Access Compliance Report

Public Rights-of-Way

(Curb Ramps)

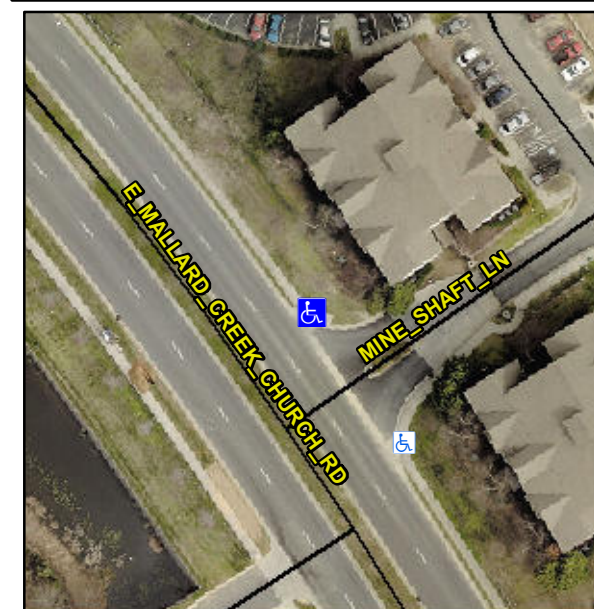
Intersection ID: 49097	Main Street: MINE_SHAFT_LN	Cross Street: E_MALLARD_CREEK_CHURCH_RD	Location: N
ADA ID: 43D49D1E99E8	Ramp Type: Perp	Initial Pass/Fail: Fail	Overall Compliance: No
Severity Score: 13.75			
Codes/Mitigation Info/Possible Solution		Field Measurements/Component Compliance

R304.2.2, R304.5.3

Compliance	Description	Data	Compliance	Description	Data
N/A	Ramp Length (in)	60.5	No	Ramp Slope (%)	10.9
Yes	Ramp Width (in)	49.0	No	Ramp XSlope (%)	4.1
N/A	Flare Type LT	N/A	N/A	Flare Type RT	N/A
N/A	Flare Slope LT (%)	N/A	N/A	Flare Slope RT (%)	N/A
N/A	Flare Traversable LT?	N/A	N/A	Flare Traversable RT?	N/A
N/A	Landing Length (in)	N/A	N/A	DWS Provided?	N/A
N/A	Landing Width (in)	N/A	N/A	DWS Contrast?	N/A
N/A	Landing Slope (%)	N/A	N/A	DWS Length (in)	N/A
N/A	Landing X Slope (%)	N/A	N/A	DWS Full Width?	N/A
N/A	Landing Curb? (Y/N)	N/A	N/A	DWS Offset (in)	N/A
N/A	Shared Landing?	N/A			
N/A	Gutter Ponding?	N/A	N/A	Gutter Slope (%)	N/A
N/A	Gutter Lip Ht (in)	N/A	N/A	Gutter X Slope (%)	N/A
N/A	Painted X Walk1?	No	N/A	Painted X Walk2?	N/A
	X Walk 1 Direction	To SE		X Walk 2 Direction	N/A
N/A	X Walk 1 Width (in)	N/A	N/A	X Walk 2 Width (in)	N/A
	X Walk 1 Slope (%)	0.3		X Walk 2 Slope (%)	N/A
	X Walk 1 X Slope (%)	3.5		X Walk 2 X Slope (%)	N/A

Remove & Replace Entire Ramp.
